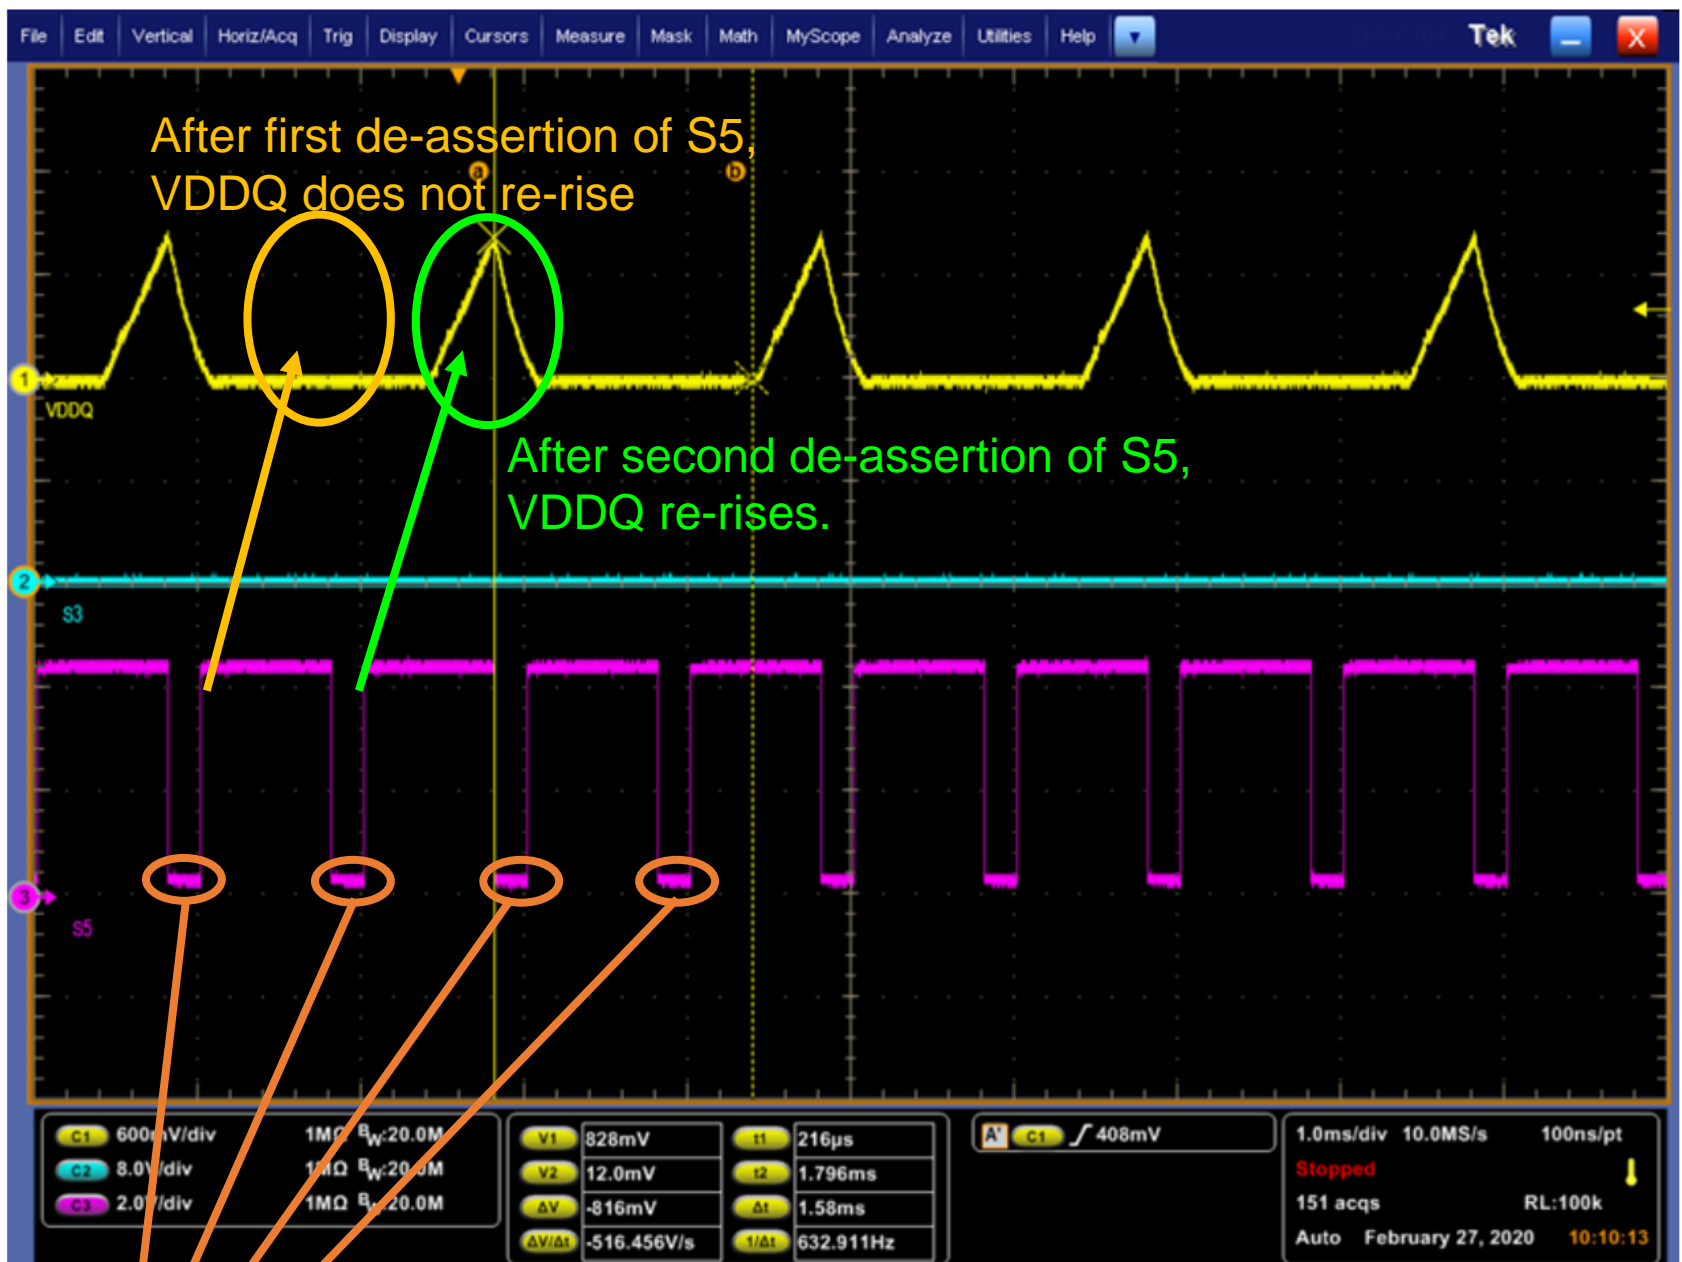
We think that if the S5 de-assertion time is less than 200us, VDDQ will not re-rise.

(Request)
Could you make the assertion
time of the S5 signal 100msec?
